Agenda
Village of Glen Ellyn
Special Village Board Workshop
Monday, August 26, 2024
6:00 PM
Glen Ellyn Civic Center, Room 301

Discussion of the Acceptance of the Public Improvements for the Main Street Garage

400 Apex Parking Facility Visual Review

April 14, 2023

Connection Type 87 from Mid-States Precast Drawing SP303

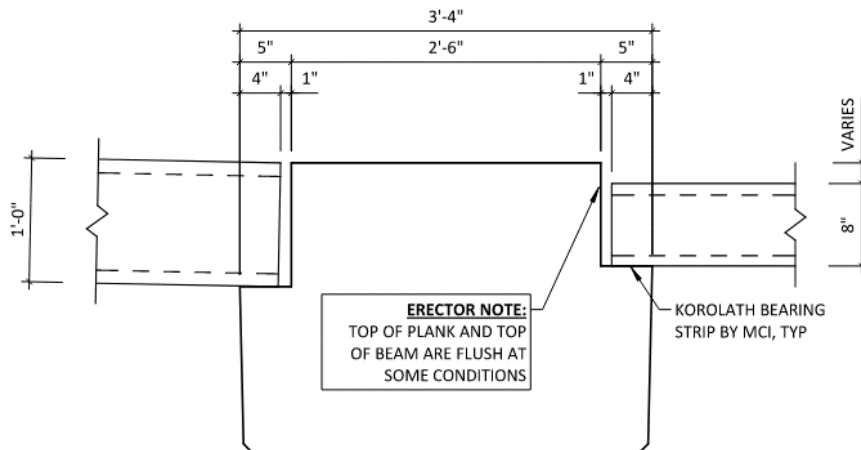
- b. Spall locations 1, 2, and 3 were specified to have Connection Type 87. We noted that this connection detail, shown below, does not include a steel dowel that was observed in the field. The steel dowels observed appear similar to the pins shown in Connection Type 103 above. The

connection detail also specifies a “Korolath Bearing Strip,” but we were unable to observe a bearing pad along the joint or within the spalled cavity from the ground. We noted the opposite end of the plank was specified to have Connection Type 110, which includes a welded fixed bearing.

Photo 9. Spall 4 along Grid 7.8 from Photo 8. Note, presence of a bearing pad is not obvious from ground.

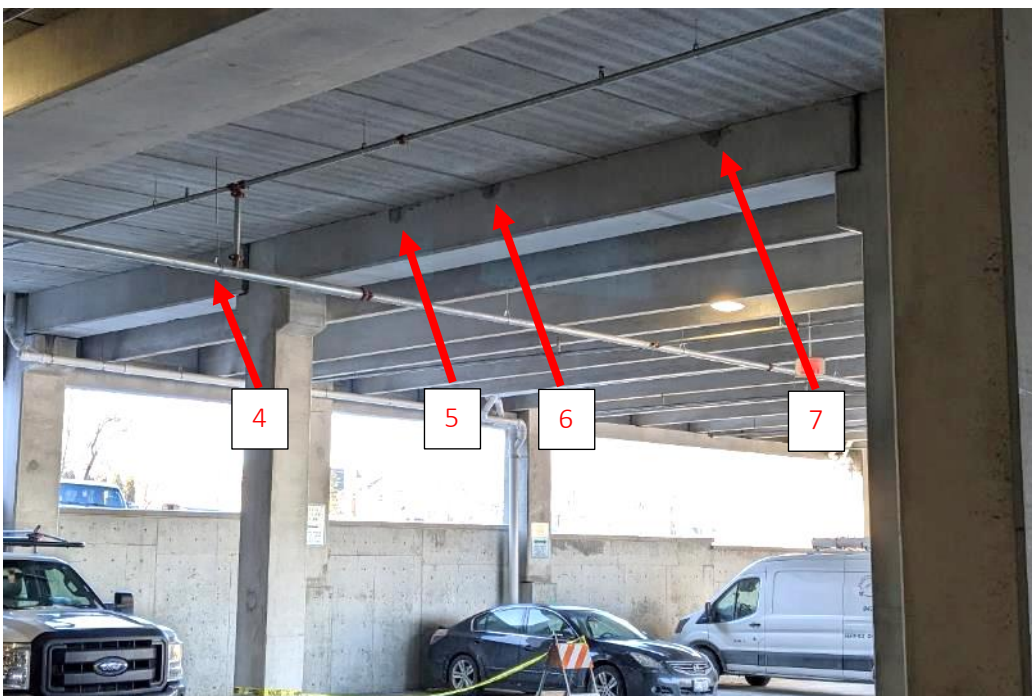
- d. Spall 4 along Grid Line 7.8, between Grids D and E. Concrete was reported to have fallen to the ground at this location in January 2023. The spall appeared shallow and was semicircular in shape. The presence of a bearing pad was not obvious from the ground.

Photo 10. Spall 5 along Grid 7.8 from Photo 8. Note, presence of dowel at center of spall. Also note an adjacent small spall. Presence of a bearing pad is not obvious from ground.

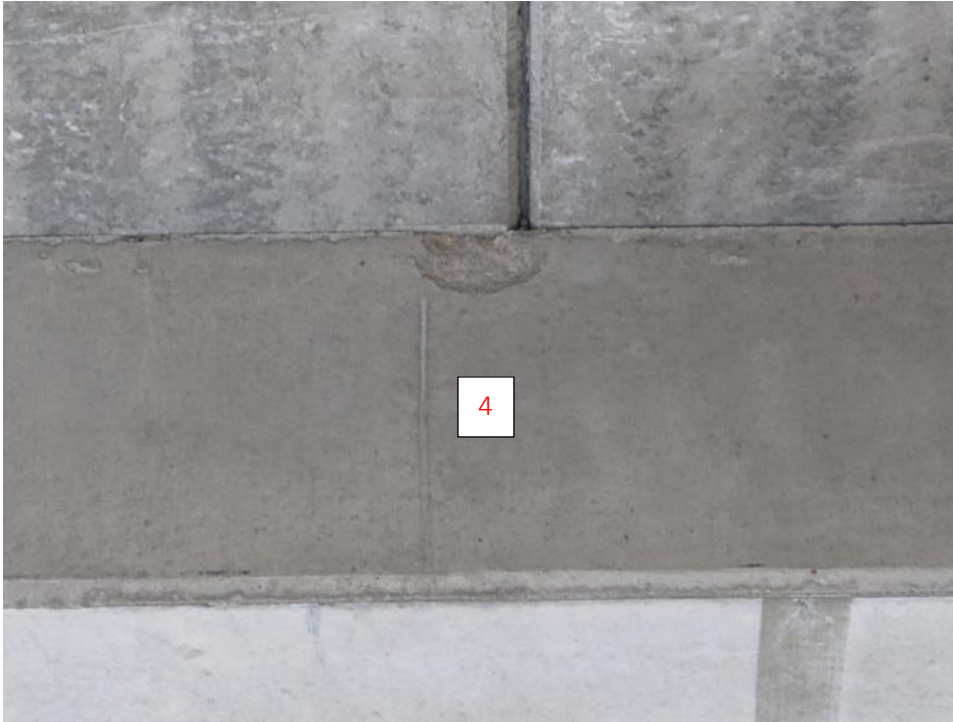
- e. Spalls 5, 6, and 7 along Grid Line 7.8, between Grids C and D. Concrete was reported to have fallen to the ground at this location in January 2023. The spalls were semicircular in shape. A steel dowel with adhesive appeared to be present at the center of each of the spalls with the spall radiating outward from the dowel. Some corrosion appeared to be present on the steel dowel. Adhesive surrounding the dowel was not obvious.

Photo 13. Spall 8 along Grid 7.8.

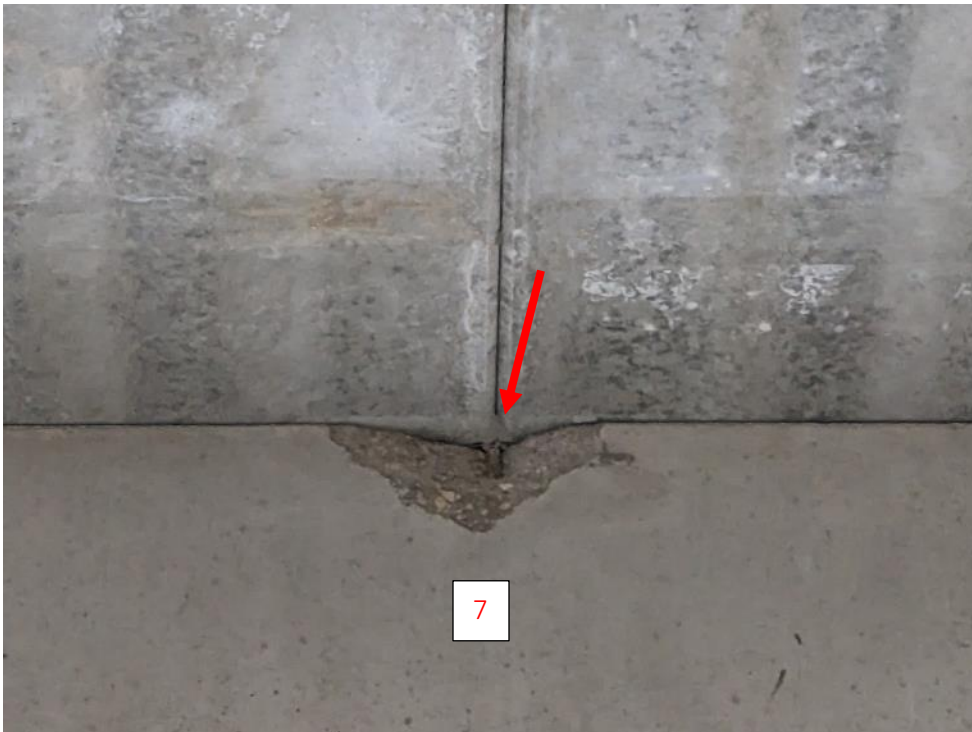
- f. Spall 8, along Grid Line 7.8, at Grid C. Concrete was reported to have fallen to the ground at this location in January 2023. The spall was semicircular in shape. A steel dowel with adhesive appeared to be present at the center of the spall and the spall radiating outward from the dowel.

(A1) SECOND FLOOR PLAN
5/8" = 1'-0"

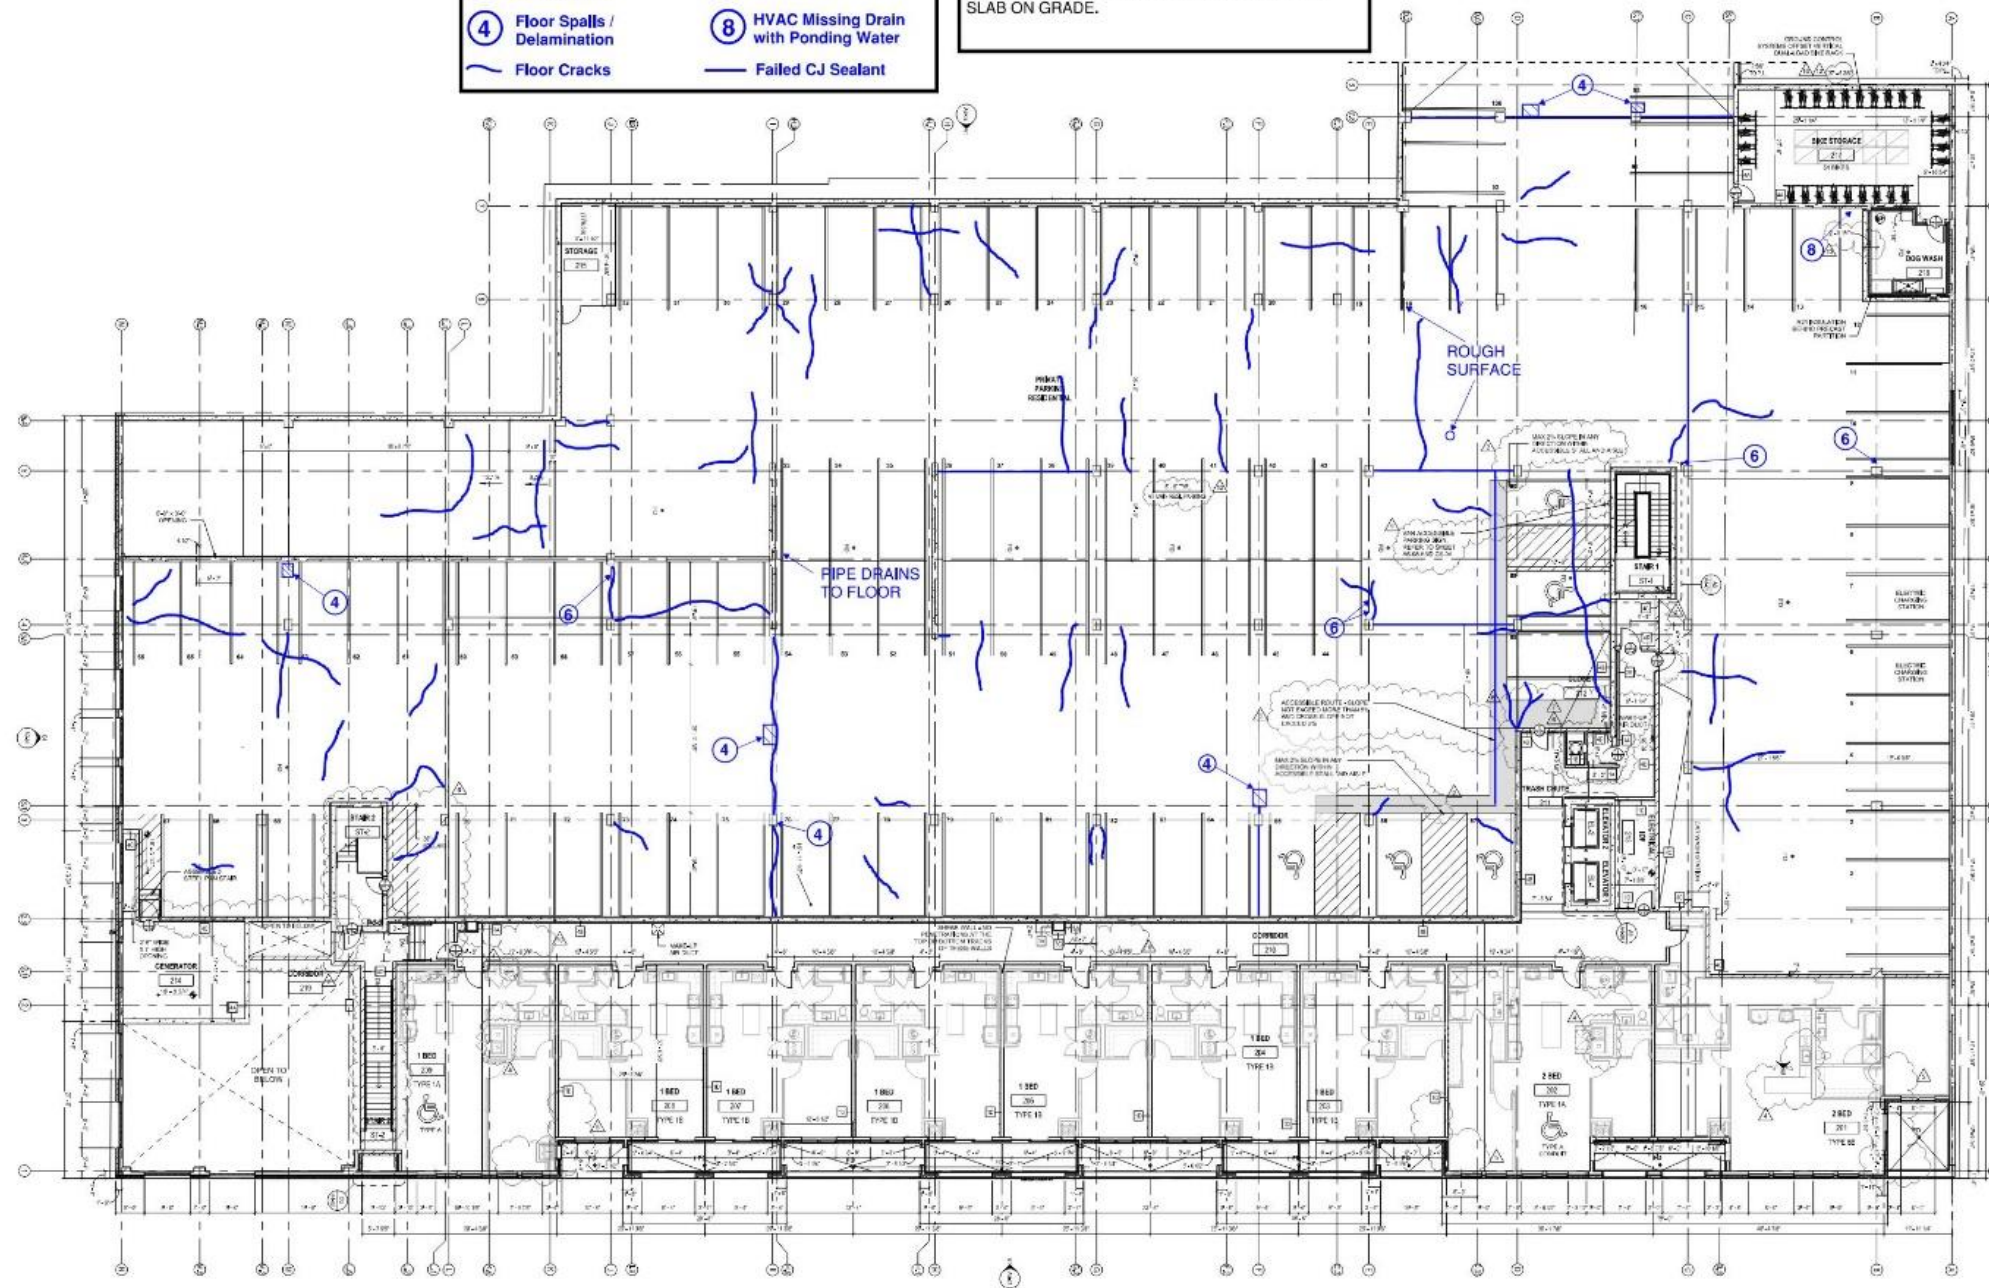
1. A few concrete cracks and delaminations were present in the floors at isolated locations (Photos 48 & 49).
2. We noted that the 2nd level topping slab did not have control joints at each hollow core slab joint, as is frequently used in parking structures, but incorporated a nominal 15'x15' control joint pattern.
3. Floor cracks in the concrete topping were common throughout the 2nd level floor and may allow water penetration (Photos 50 to 56). The cracks varied in size from hairline to over ¼" at one location. The

floor cracks were often observed parallel to the hollow core plank joints where control joints were omitted and at some locations perpendicular to the hollow core. Cracks were also noted to radiate from some wall corners and through pipe penetrations.

4. Prematurely failed control joint sealant was frequent throughout the 2nd level (Photos 58 to 61).
5. Cove sealants were present at the wall-to-floor interface at some locations, typically near the south end, but were missing at many locations resulting in an open joint that can allow for water penetration through the floor slab (Photo 62). Additionally, unsealed joints were typically present at the shear walls (Photo 63) and columns (Photo 64).
6. The perimeter around pipe penetrations through the floor were typically unsealed and can allow water penetration through the floor slab (Photos 65 and 66).
7. The finger floor was not visually surveyed due to snow and ice covering the surface at the time of the visit.

A3 SECOND FLOOR PLAN AT FINGER
1/8" = 1'-0"

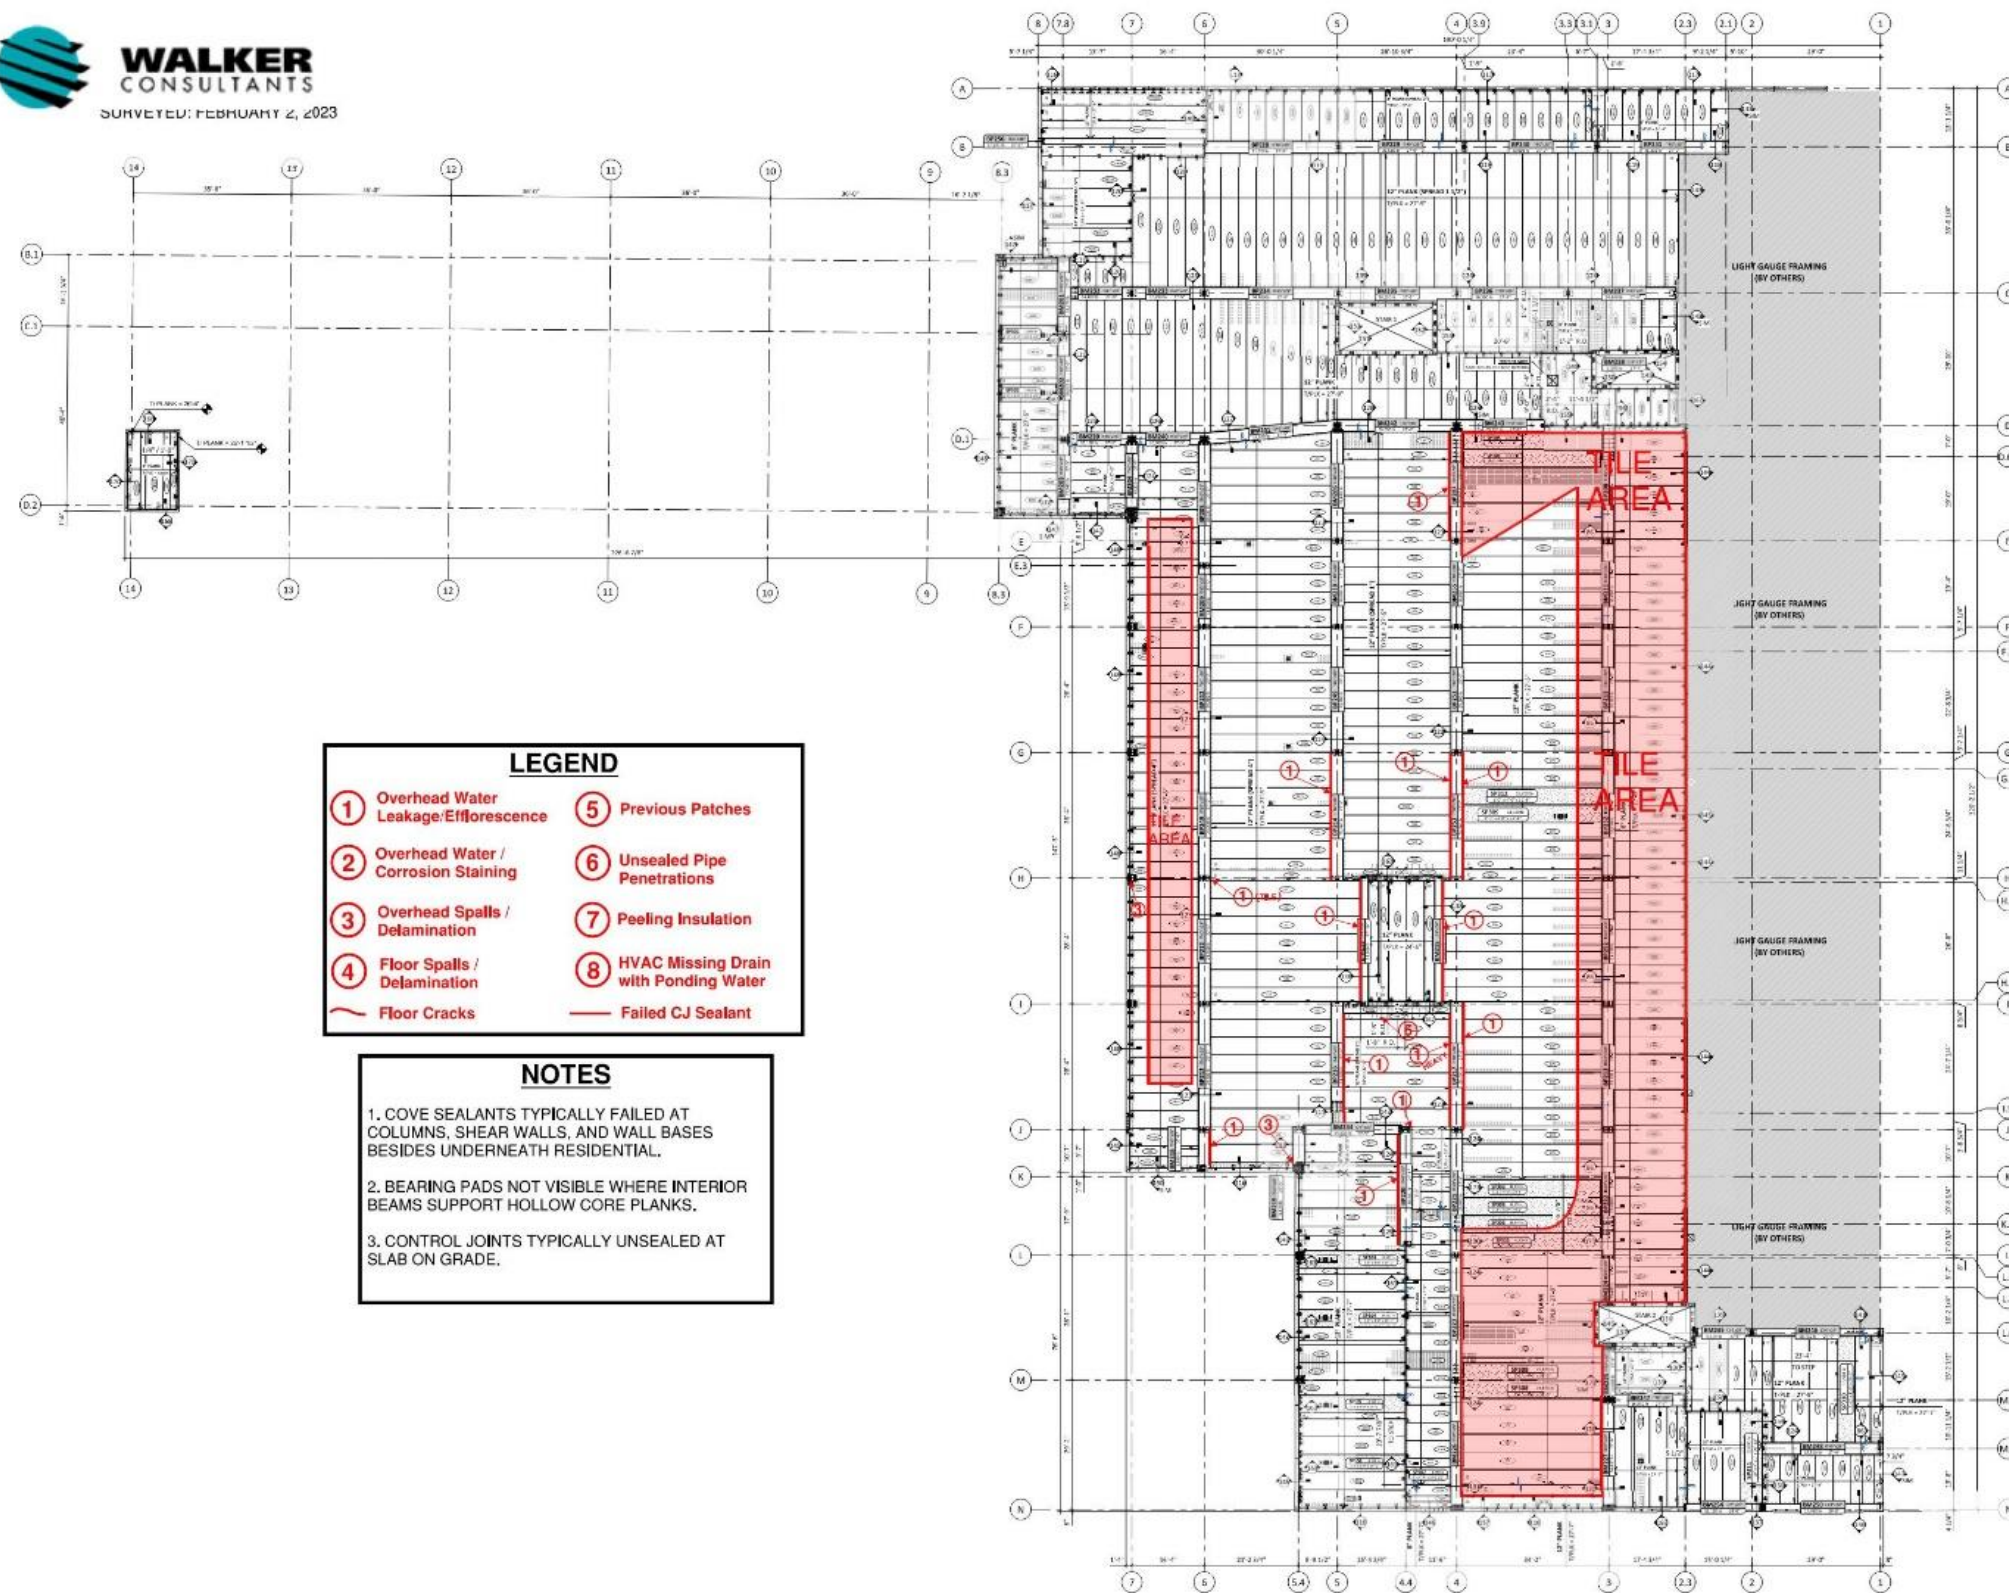
1. Water staining and efflorescence was common on the sides of overhead beams due to water leakage through the floor, typically the full span length of the beam from column to column. In some cases, there was corrosion staining (Photos 67 to 69).
2. A ceiling tile was observed to be deflected and cracked. Removal of the tile revealed active water leakage through the underside of a hollow core plank from the plank void (Photo 70). The leakage had resulted in ice buildup on the ceiling tile above. The ceiling tile was removed by property management.
3. Small concrete delamination/spalls were present in a few column locations from both the interior and exterior (Photos 71 to 73).
4. A PVC pipe near a shear wall was draining directly to the floor that may result in water ponding and ice formation (Photo 74).
